ADDENDUM NUMBER ONE

October 21, 2019

PIN 125590.00 Canada Road Pedestrian and Bike Trail

**ELECTRICAL
DETAILS**

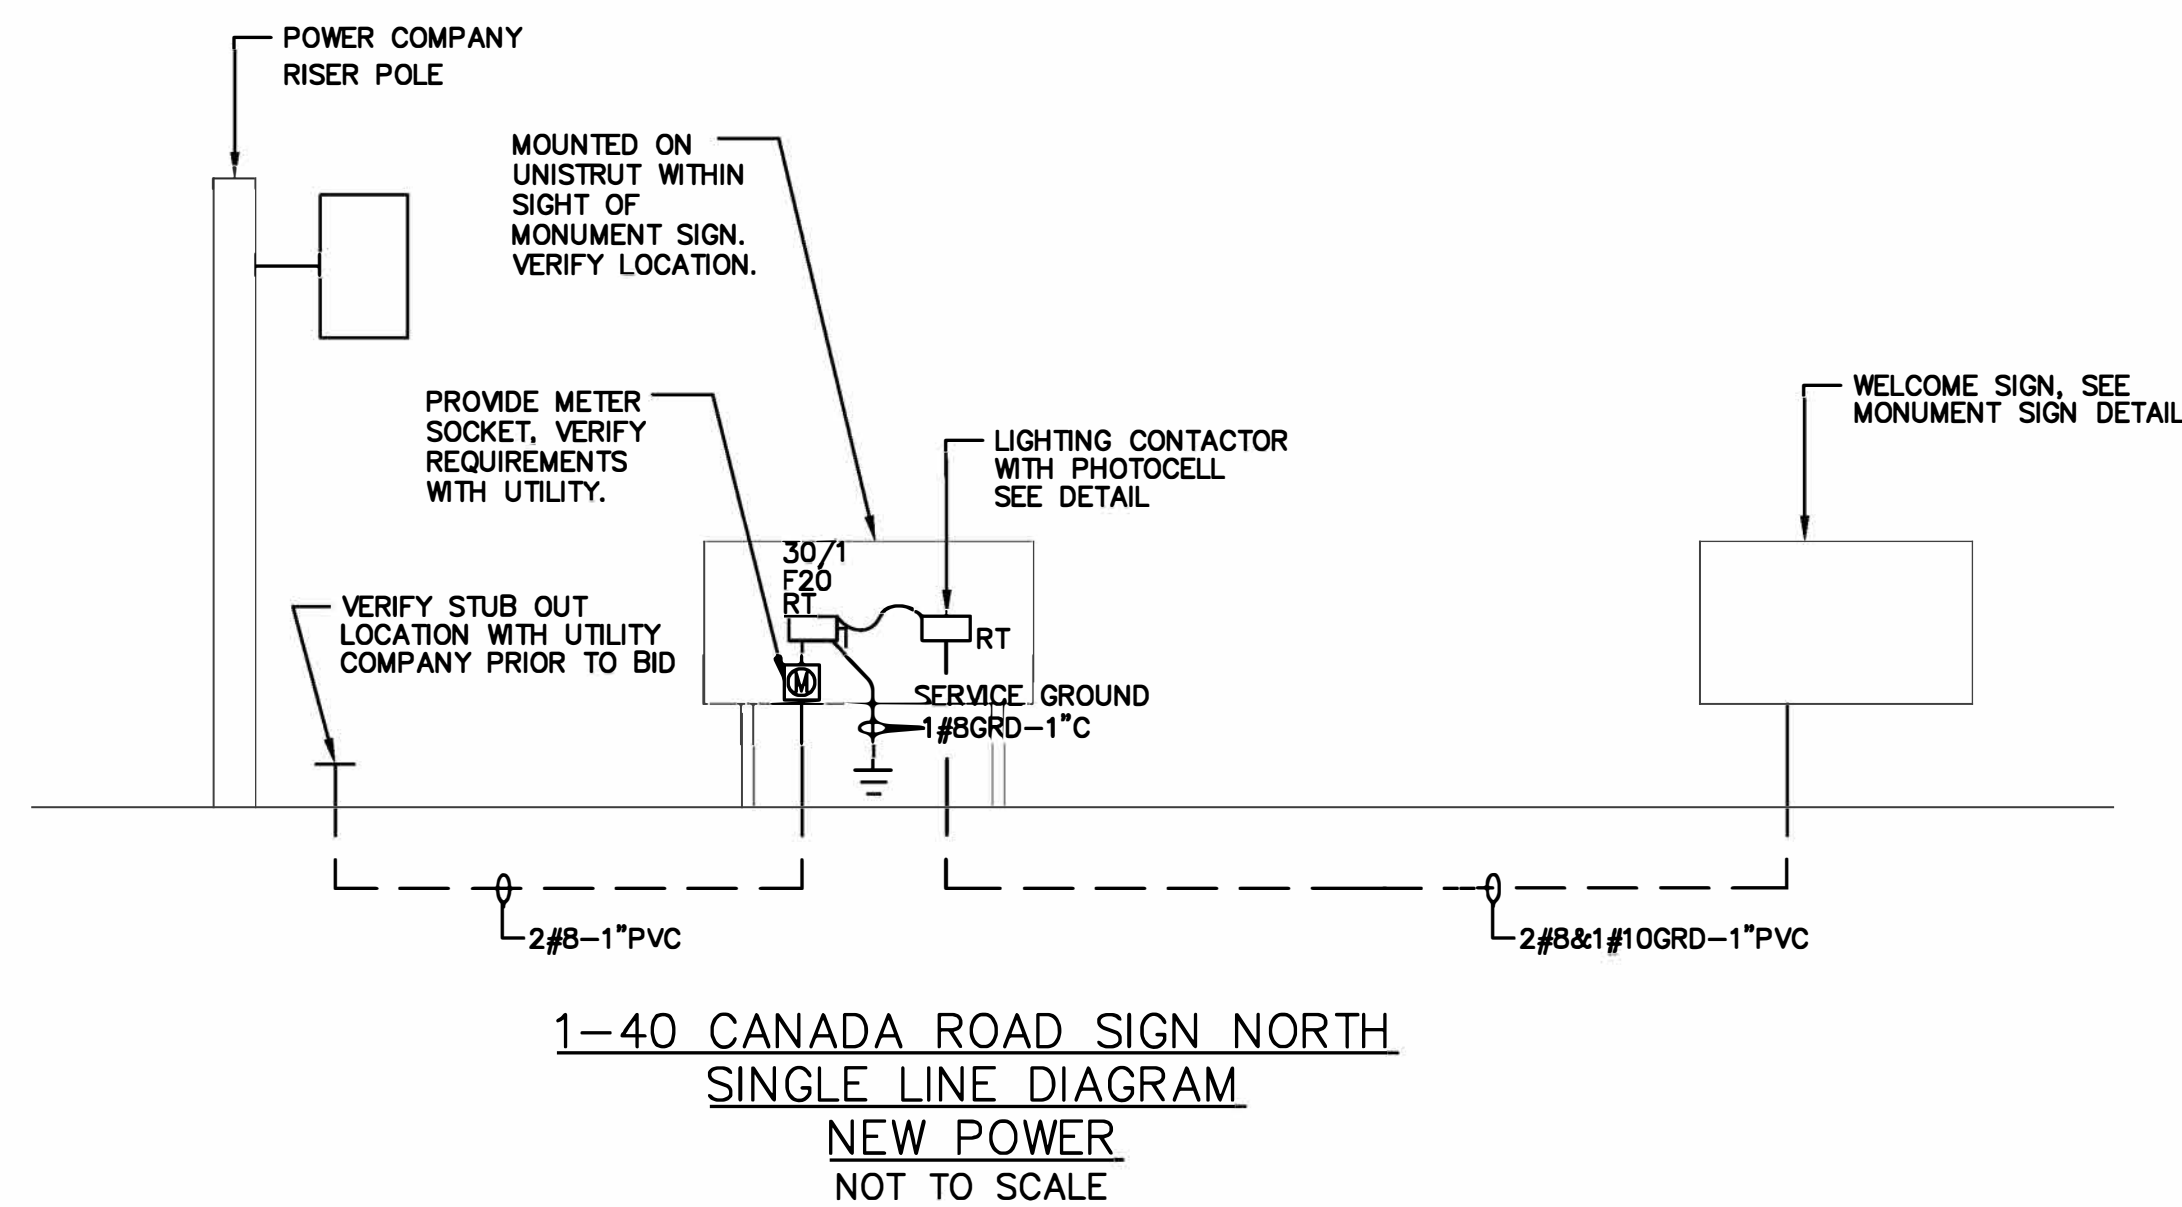
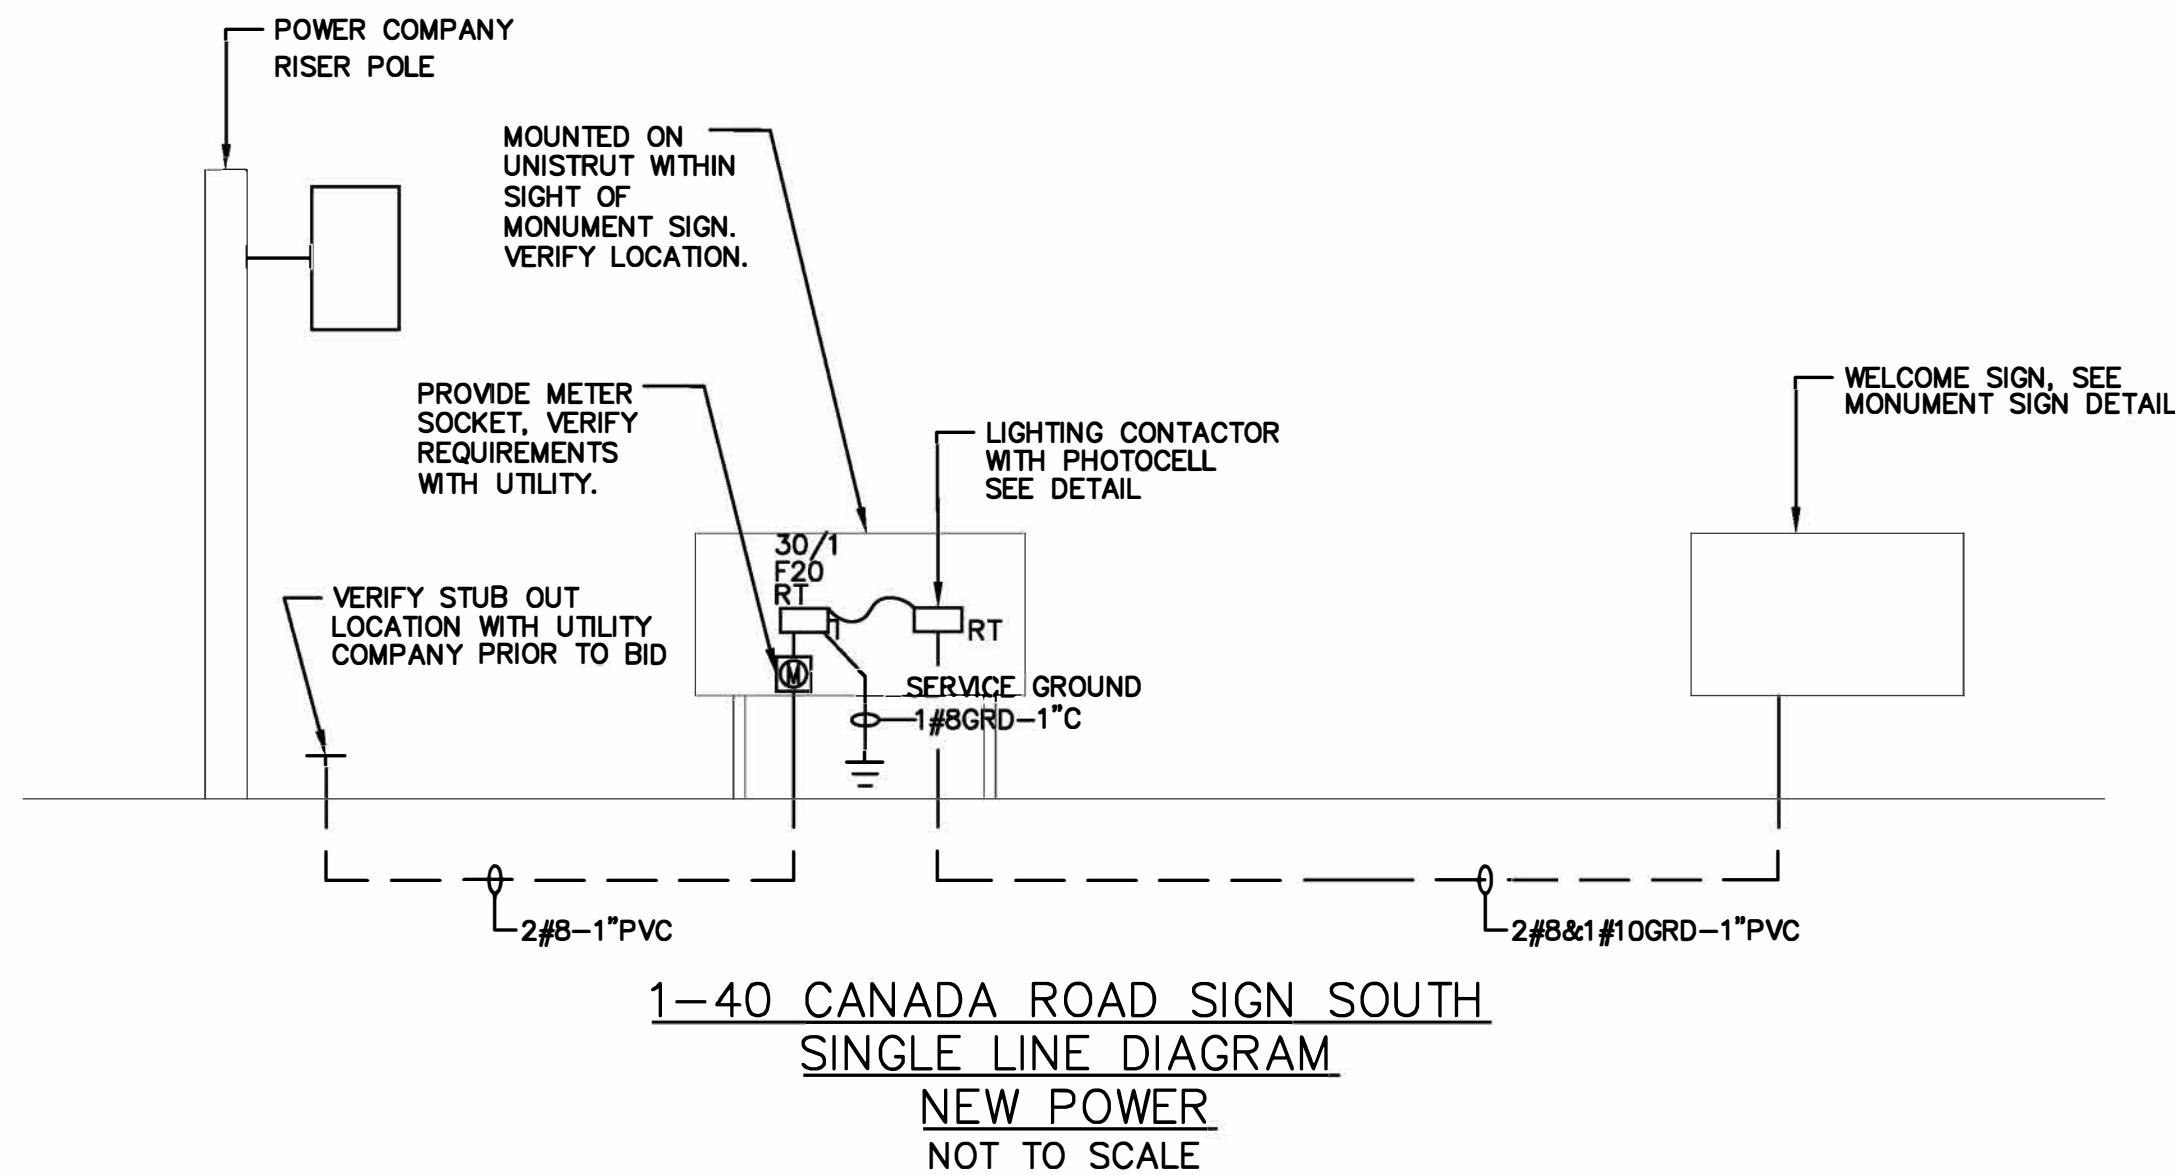
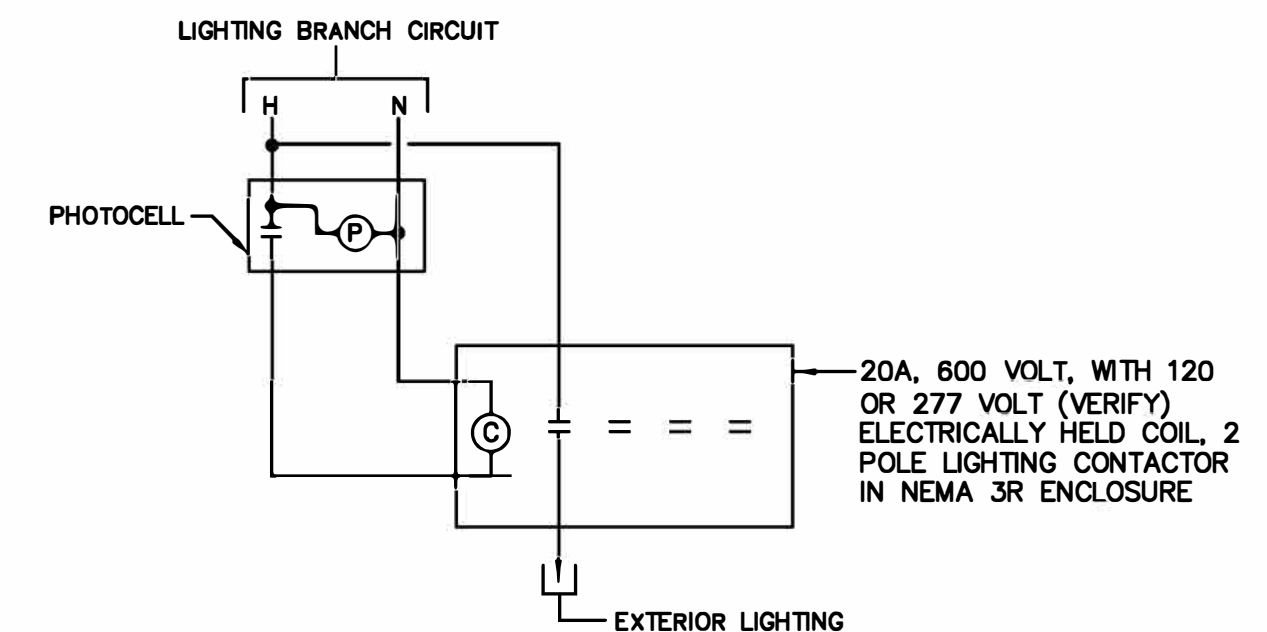
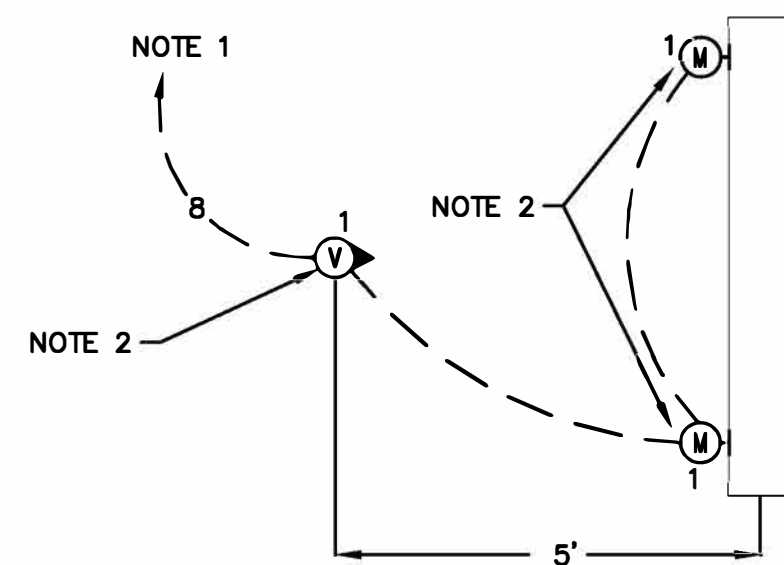
REFERENCE PLANS: NEW SHEET L-2, ELECTRICAL DETAILS

This sheet provides electrical details for the proposed signs.
